**STAFF RECOMMENDATION**

**916 Acklen Avenue**

**April 22, 2020**

**Application:** New Construction—Infill

1 **ACKLEN AVE VIEW**  
 2 1/16" = 1'-0"

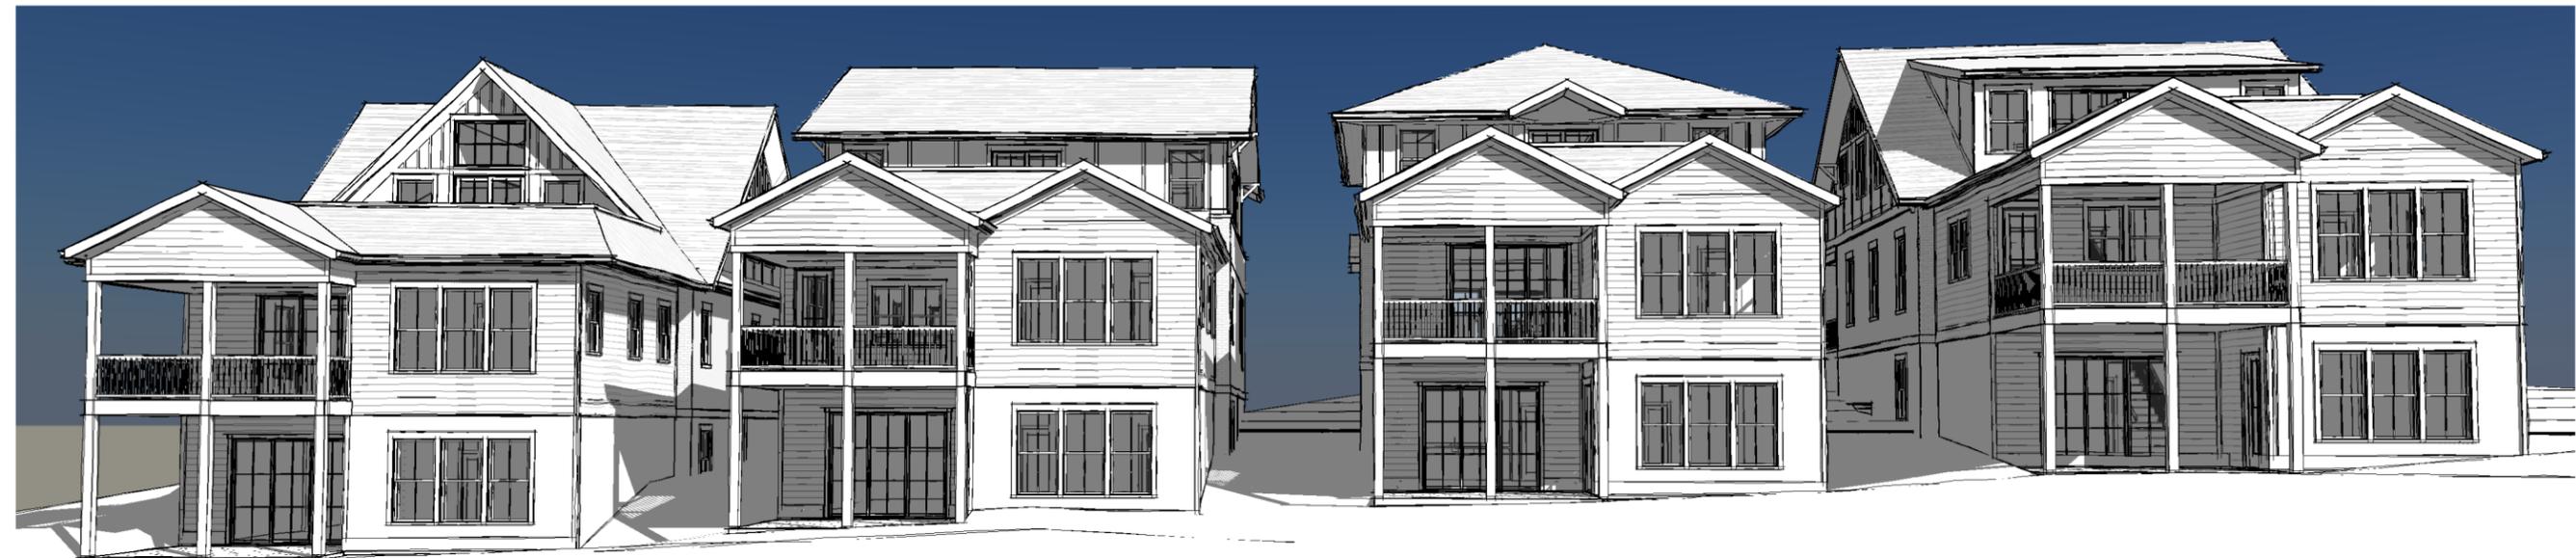
**Height & Scale:** Of the four houses, two will be two-story in height and two will be one-and-a-half stories in height. Staff finds this to meet the immediate historic context, where there are two-story historic houses mixed in with one and one-and-a-half story historic houses. The houses range in height from twenty-seven feet, four inches (27'4") to thirty

feet, six inches (30'6") above finished floor, which fits the historic context. There is a significant cross-slope and front- to-back slope on these lots. The foundations are drawn so that they are as low as possible on the houses' left sides, but it will be taller on the right sides. For lots like this, the foundation and finished floor inspections are critical to ensure that the foundation and finish floor heights match the historic context. Because the site slopes significantly from front to back, the houses gain an extra level at the rear.

Setback & Rhythm of Spacing: The applicant intends for the four infill houses to have setbacks of approximately twenty-five feet (25'), which matches the front setback of the historic house to the left of the site. The house to right has a setback of approximately thirty-five feet (35'), but because it is non-contributing, new construction, staff finds that it is appropriate for the infills to match the front setback of the adjacent historic house.

The infills are all at least five feet (5') from the side property lines, and there is approximately thirteen feet (13') of space in between the houses, which meets the setback and rhythm of spacing for the street. They will all be over one hundred feet (100') away from the rear property line.

1. The finished floor height be consistent with the finished floor heights of the adjacent historic houses, to be verified by MHZC staff in the field;
2. At least one window opening of at least four square feet (4 sq. ft.) be added to the right elevations of Houses B and D, near the midpoint or towards the rear;
3. Staff approve the brick samples, all windows and doors, the roof shingle color and texture, and the walkway and driveway materials prior to purchase and installation; and
4. The HVAC be located behind the house or on either side, beyond the mid-point of the house.

A-ELEVATIONS

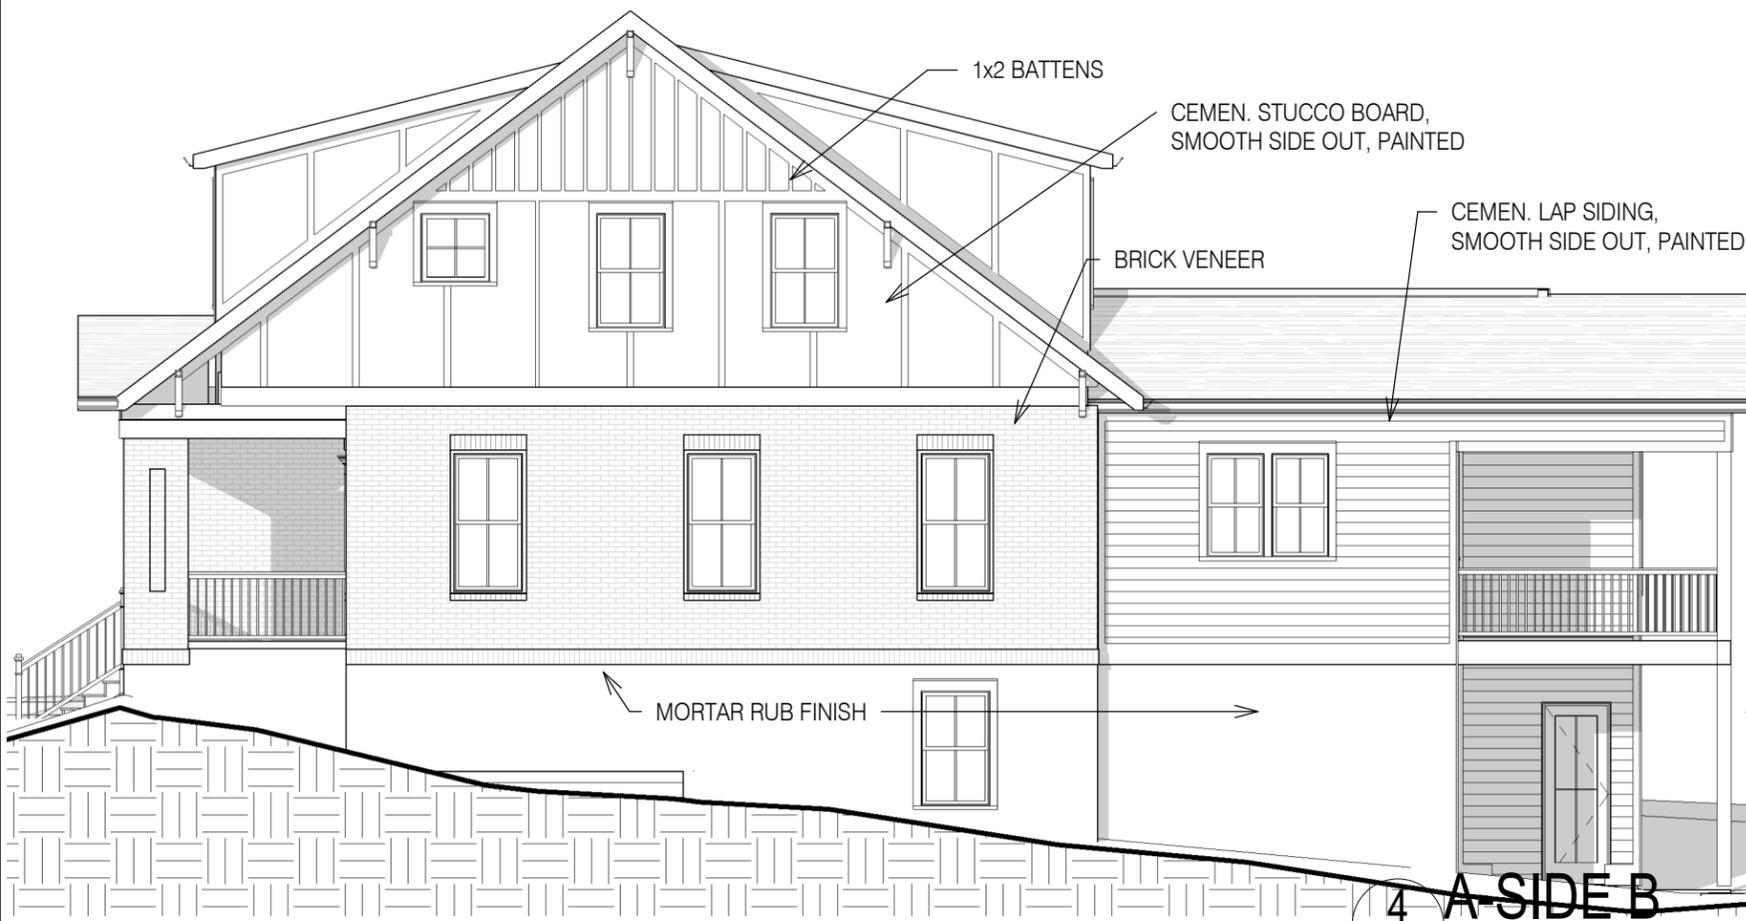
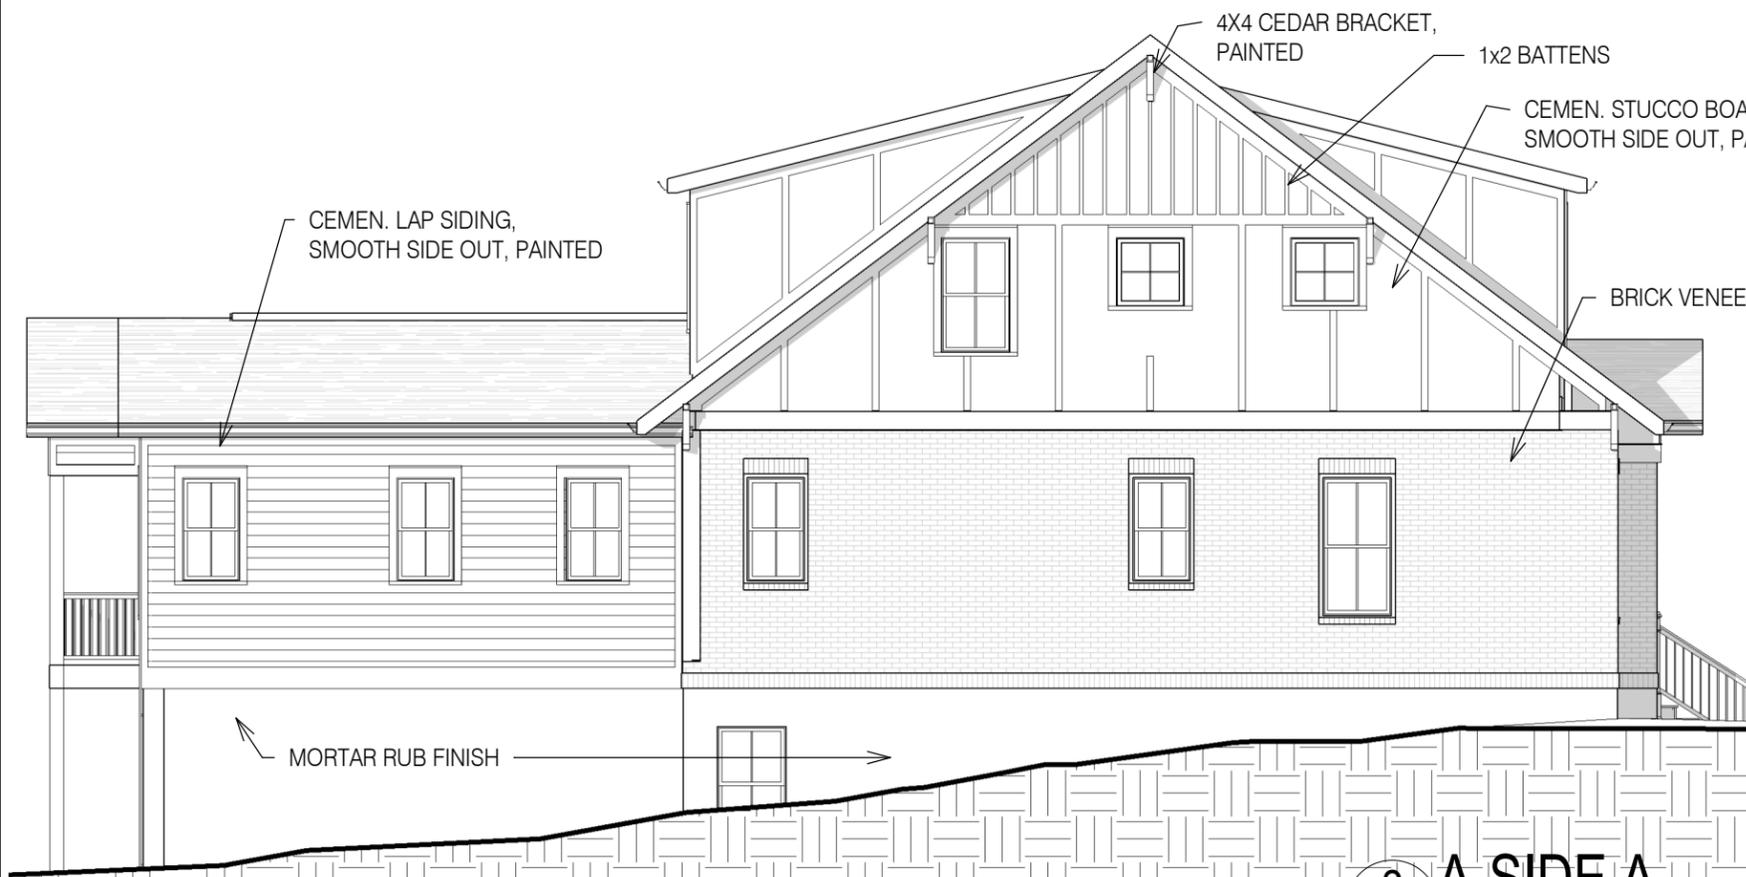
House A, which one-and-a-half stories in height, has a 9/12 side gable as its primary roof form. Its porch roof is a 3/12 gable, and it has front and rear shed dormers with a 3/12 slope. The front dormer is inset 2' from the wall below. The rear portion of the house is a 6/12 gable.

B-ELEVATIONS

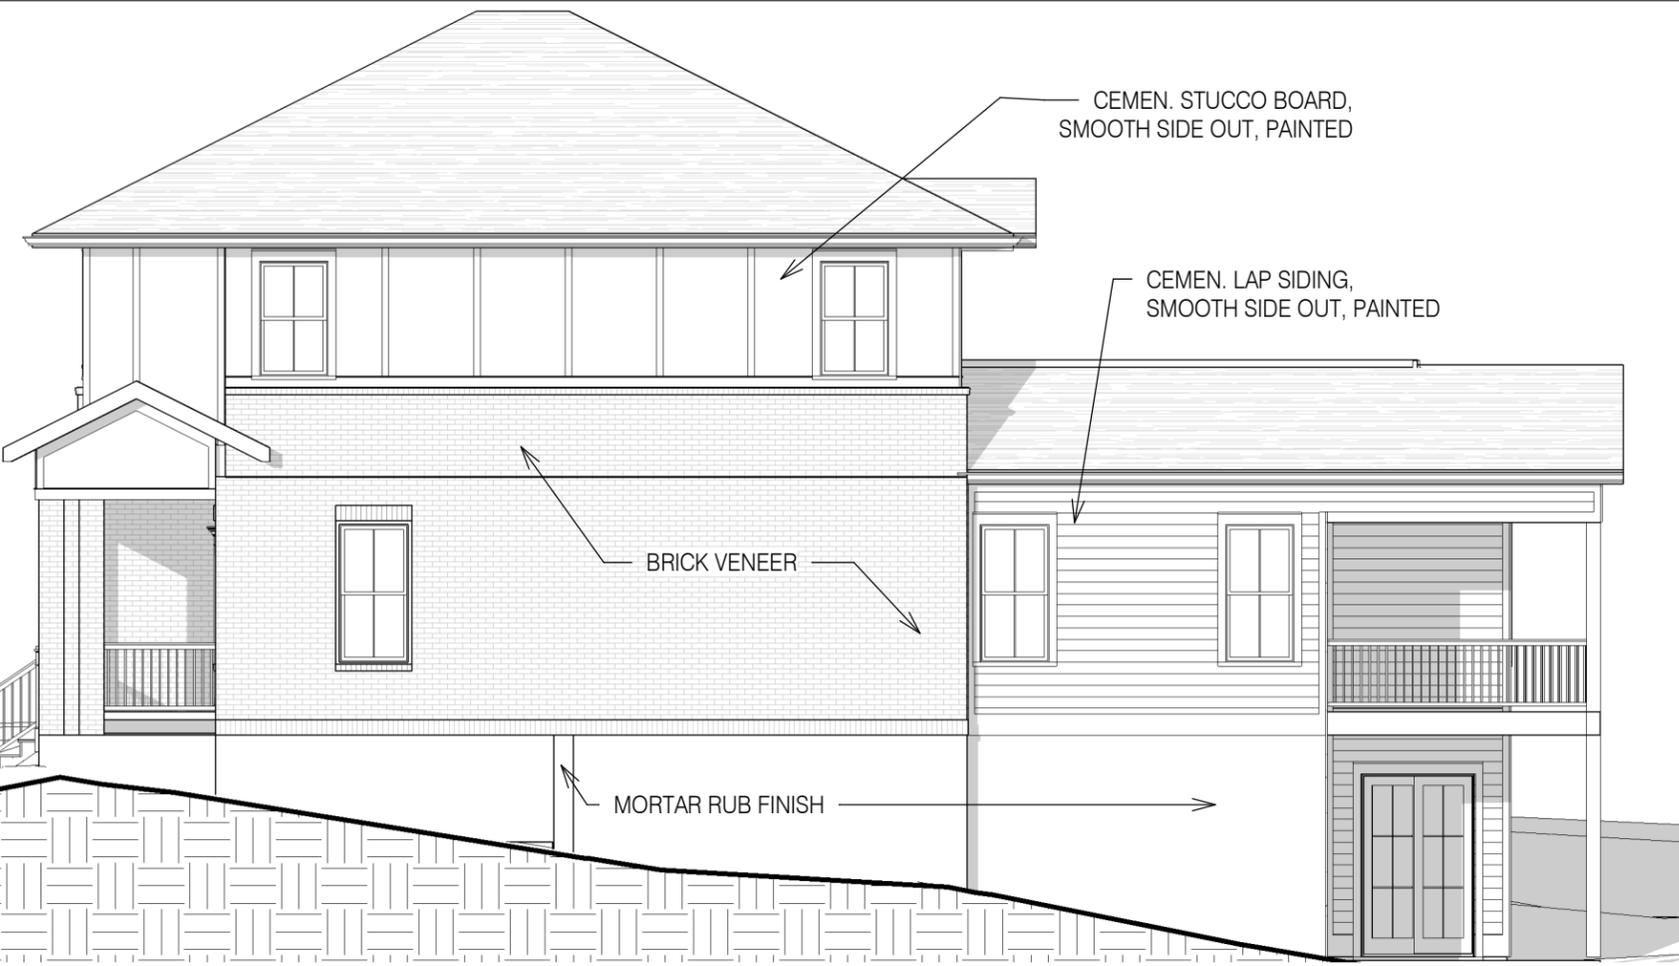
House B, which is two stories, has a 6/12 hipped roof as its primary roof form. Its front porch is a shed, and it has 6/12 gable at the rear.

Proportion and Rhythm of Openings: The windows on the proposed infills are all generally twice as tall as they are wide, thereby meeting the historic proportions of openings. Most of the facades do not have large expanses of wall space without a window or door opening, except the right elevations of House B and House D. Staff recommends that the right elevations of Houses B and D have at least one window additional window opening around the midpoint or towards the rear.
